APPLICATION NO.	FILING DATE	FIRST NAMED INVENTOR	ATTORNEY DOCKET NO.	CONFIRMATION NO.
10/066,066	01/31/2002	Robert W. Aukerman	P 1028.11004	2497

Office Action Summary

DETAILED ACTION

U.S. Patent Jan. 13, 2001 Sheet 3 of 8 US 6,176,104 B1

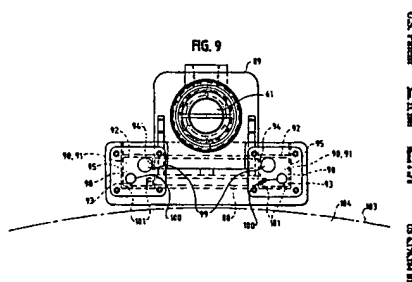
- {claim 1} An ink drying system (column 1, lines 5-9), coupled to a source of pressurized gas (figure 2, references 41, 57),

and comprising a plurality of plenums (figure 9, references 90),

each plenum including an associated plurality of orifices (figure 9, reference 101); a plurality of fluid flow valves for controlling fluid communication between the plenums and the source of pressurized gas (figure 2, reference 42); a controller (figure 2, reference 56; column 3, lines 29-52)

- {claim 2} drying portions provide substantially complete laterally extending coverage of the sheet (figure 2, references 39, 43 W; column 4, lines 63-67) and wherein the drying portion of at least one of the plenums provides a substantially different range of laterally extending coverage of the sheet than at least one other of the plenums (figure 9, references 90)
- {claim 3} at least two of the plenums are spaced substantially apart from one another in a direction of travel of the sheet by a predetermined distance (figure 9, references 90; column 4, lines 42-52) and wherein the drying portions of the plenums are each substantially laterally co-extensive (figure 9, references 90; column 4, lines 63-67; column 5, lines 1-2)
